DAP-725

**Review of Facilities for Automation
Glenn-Colusa Irrigation District
Willows, California**

**U.S. Department of the Interior
Bureau of Reclamation**

April 2, 1996

Photograph 1. - Willows check - typical radial gate check structure on Glenn Colusa canal.

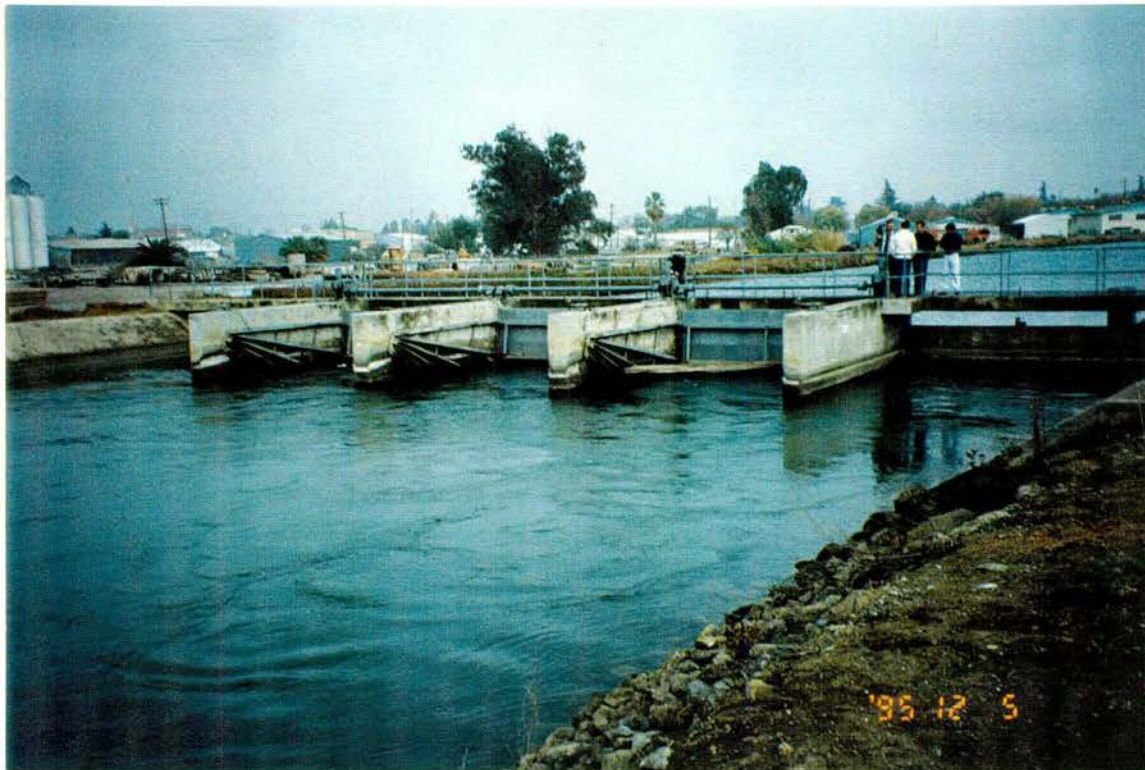
- The Willows check structure is a typical radial gate structure. Because of its proximity to the District's office, it would be an excellent site for first phase modernization activities.

Photograph 12. - Glenn Colusa pumping plant bypass flow (note fish trap).

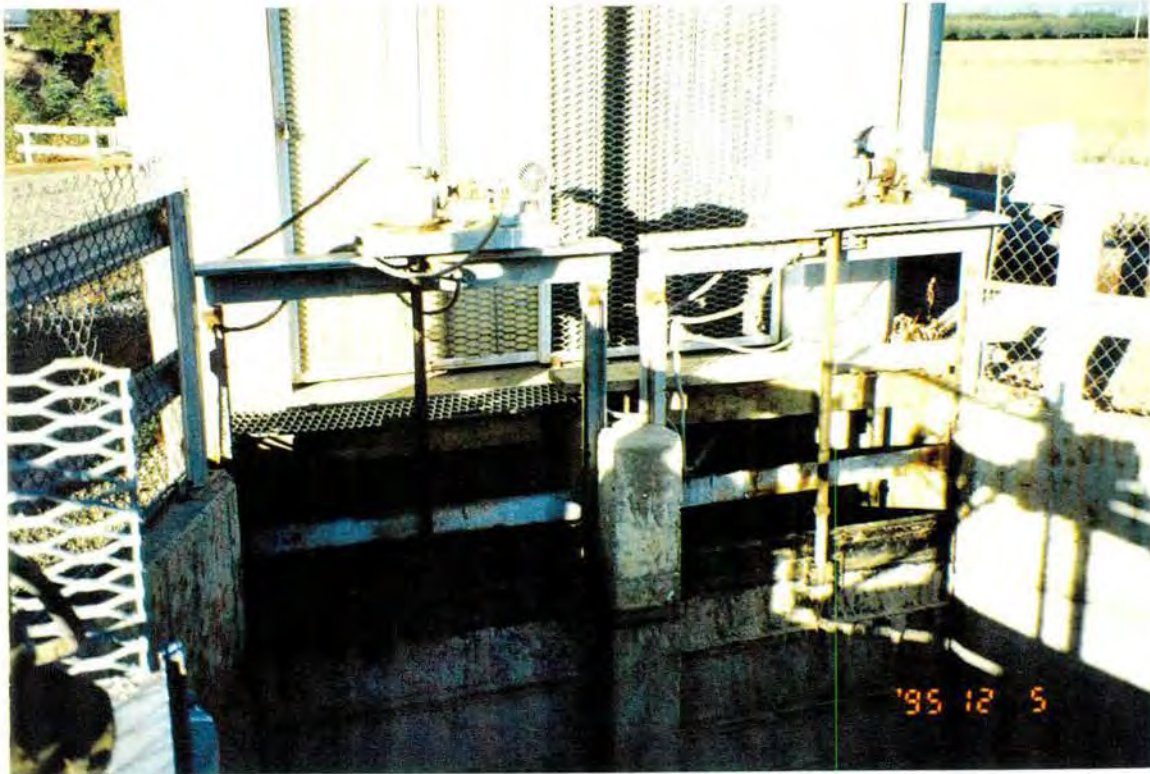
- Photograph 11 shows the main pumping plant. The plant is controlled by Allen-Bradley controllers. These controllers are well suited to plant operations; however, they need to be updated. If newer generation Allen-Bradley controllers are chosen, the data could be interpreted by an Allen-Bradley driver for the Genesis or Wonderware software at the master site or at the alternate master site (the pumping plant). The data from the canal control system can then be used in a supervisory control mode to make flow changes at the pumping plant.
